# SUBDIVISION REPORT - CONCEPT/USE ON REVIEW

► **FILE #:** 12-SA-21-C  
12-A-21-UR

► **SUBDIVISION:** AMBER RIDGE (FKA AMBER MEADOWS)  
► **APPLICANT/DEVELOPER:** URBAN ENGINEERING, INC.  
**OWNER(S):** JOL, LLC

CONCEPT PLAN / USE ON REVIEW

SHEET C-1 2 OF 5

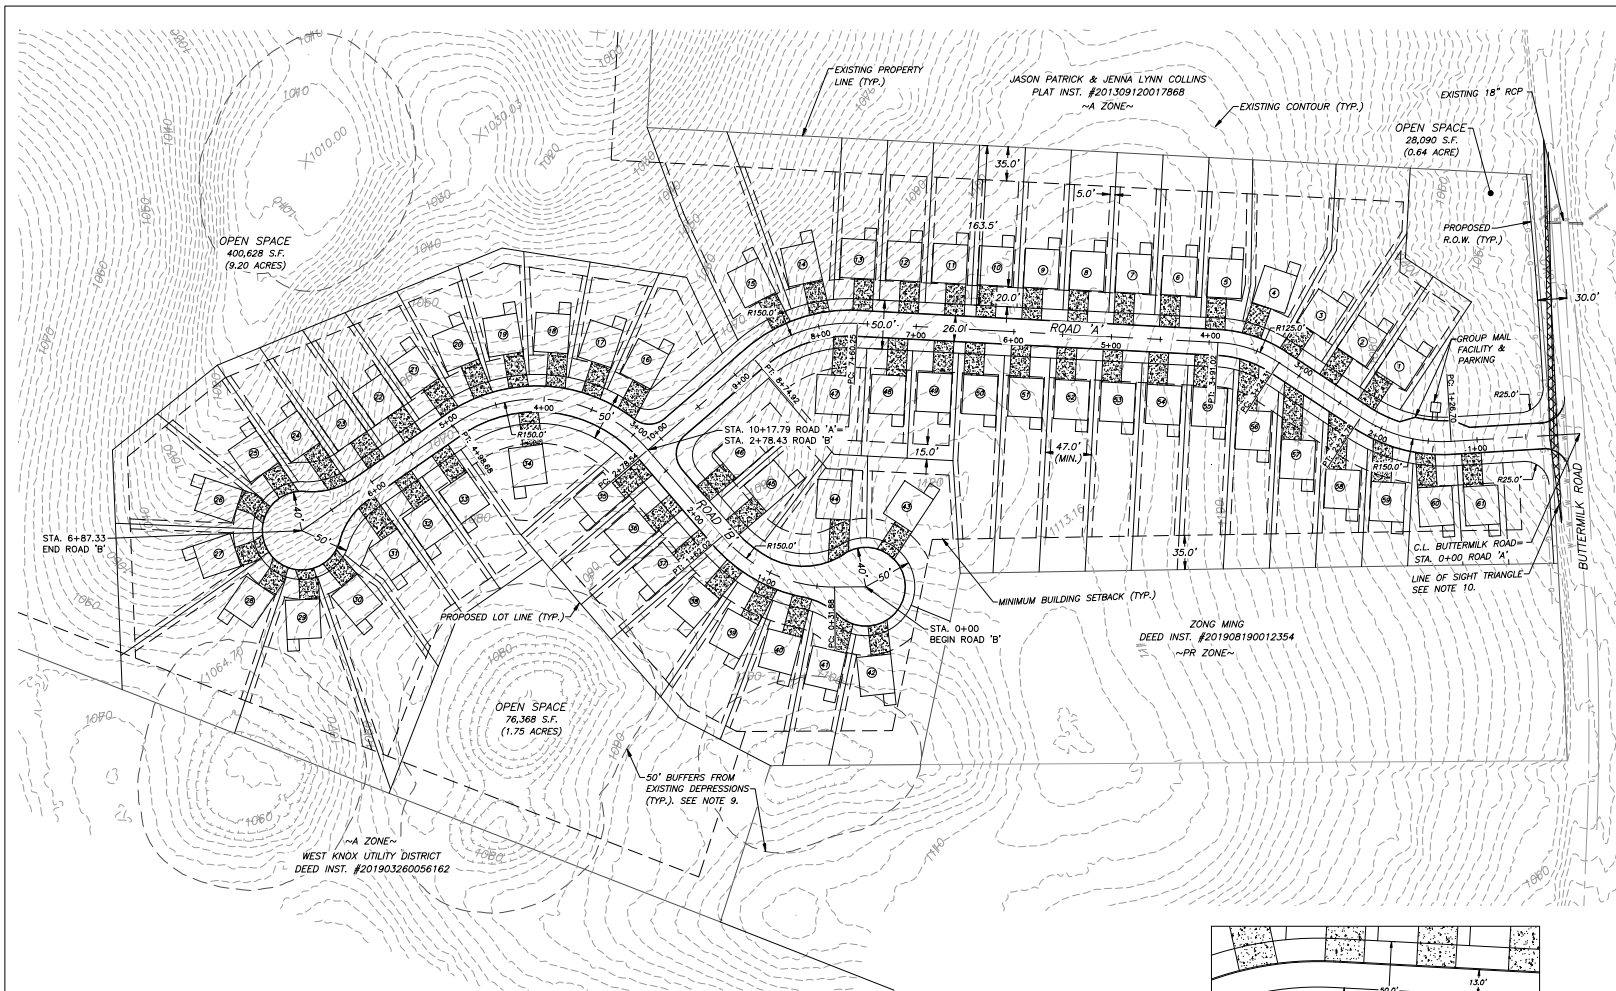
1. Connection to sanitary sewer and meeting any other relevant requirements of the utility provider.
2. Provision of street names which are consistent with the Uniform Street Naming and Addressing System within Knox County (Ord. 91-1-102).
3. During the design plan stage of the subdivision review process the applicant shall work with the Knox County Department of Engineering and Public Works and Planning staff to minimize the clearing and grading of the common areas identified on the concept plan. When the grading and stormwater plans are finalized, the design

plan shall identify the areas within the common area that are to remain as natural undisturbed areas. These areas shall be identified on the final plat and in the protective covenants for the subdivision as natural undisturbed areas with a prohibition on any clearing and grading except what would be needed for a passive trail system. The boundary for the natural undisturbed areas shall be clearly marked in the field prior to any site grading in order to identify the limits of disturbance and protect those areas of mature vegetation.

4. The 50-ft building setback from the sinkholes/closed contours on the site shall be shown on the final plat. Building construction within the 50-ft setback may be permitted if a geotechnical study prepared by a registered engineer states that building within the 50-ft sinkhole buffer is acceptable and the study is approved by the Knox County Department of Engineering and Public Works. The geotechnical study must be completed and submitted to Knox County Department of Engineering and Public Works prior to submission of the final plat for any lots that do not have a building area outside of the 50-ft setback area. A 5-ft drainage easement extending outside of the uppermost closed contour is required. Building construction is not permitted within the hachured contour area of the sinkhole or the drainage easement. Engineered footings may be required for any structures within the 50' sinkhole buffer.

6. Providing legal access to all common areas. The minimum width of pedestrian accesses shall be 15-ft. The width of all other accesses, either access easements or fee simple strips, shall be determined by Knox County Engineering and Public Works during the design plan phase.

7. Providing a 50-ft wide stubout right-of-way on the south side of the southern Road 'B' cul-de-sac to the provide alternative access for the property to the south (parcel 129 07701).

The applicant is proposing to subdivide this 25.9 acre site into 61 detached residential lots and 11.59 acres of common area at a density of 2.35 du/ac. The property is located on the northwest side of Buttermilk Road, west of Graybeal Road. The proposed subdivision will be served by public streets with a single access to Buttermilk Road. The property was rezoned from A (Agricultural) to PR (Planned Residential) up to 3 du/ac in 2019 (4-M-19-RZ). The Planning Commission approved a 31-lot subdivision and two subdivision variances in 2019 (11-SC-19-C / 11-G-19-UR). The variances were to decrease the vertical curve from K=25 to K=15 at the Road 'A' connection to Buttermilk Road and increase the maximum road grade from 12% to 14.93%. The primary difference between the 2019 concept plan and the current plan is that Road B is extended further to the northwest and the typical lot width is reduced from 60-ft to 47-ft.

The proposed subdivision layout includes approximately 11.59 acres (45%) of the site in common area which covers some of the steeper portions of the site. Staff is recommending a condition that during the design plan stage of the subdivision review process, the applicant shall work with the Knox County Department of Engineering and Public Works and Planning staff to minimize the clearing and grading of the common areas. When the grading and stormwater plans are finalized, the design plan shall identify the areas within the common area that are to remain as natural undisturbed areas. These undisturbed areas must be clearly marked in the field prior to any site grading in order to identify the limits of disturbance and protect those areas of mature vegetation.

A geotechnical study has already been submitted to Knox County Engineering and Public Works for review and approval. The study concludes that lots identified within a 50-foot sinkhole buffer zone will have no greater risk of sinkhole development than in areas outside the buffer zone. Additional recommendations for site design and construction to reduce the potential for sinkhole development are also provided in the study.

C. The entire property is located in the HP (Hillside Protection) area. The recommended maximum land disturbance is 16.4 acres of the 25.9 acre site (63.5% of the HP area). The proposed land disturbance is approximately 16.3 acres.
